SERVICE BULLETIN

No. 198

SUBJECT: Replacement of Tail Brace Clevises

MODELS AFFECTED: PA-22-108 Colt Aircraft - Serial Nos. 22-8000 to 22-8042 inclusive

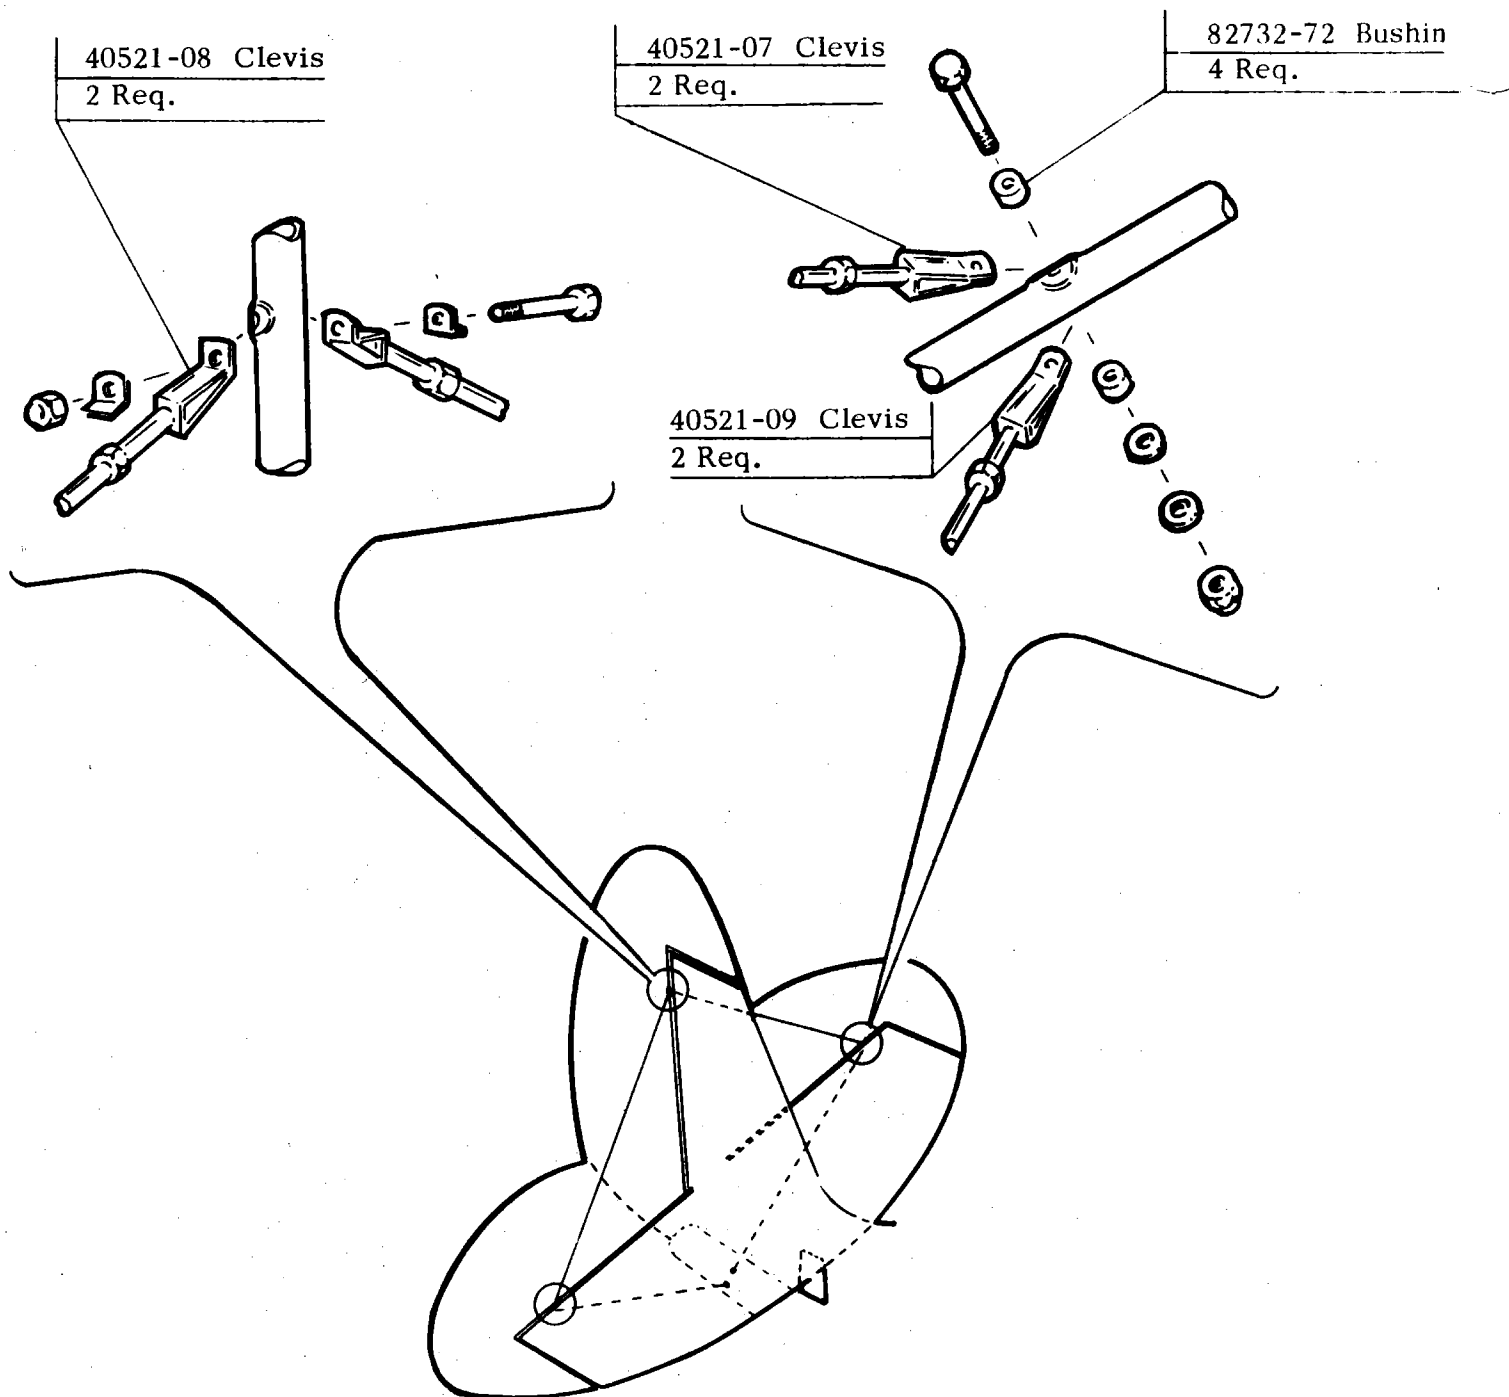
The tail brace clevises and bushings on the aircraft indicated by the above serial numbers are to be replaced.

The sketch on the reverse side of this Service Bulletin will indicate the location of the clevises and bushings to be changed.

Kit No. 754 381, consisting of six (6) clevises and four (4) bushings to comply with this Service Bulletin, will be forwarded by automatic factory distribution. The kit will be provided on a no charge basis. A compliance card is furnished with the kit for this modification. This card must be signed and immediately returned to the factory.
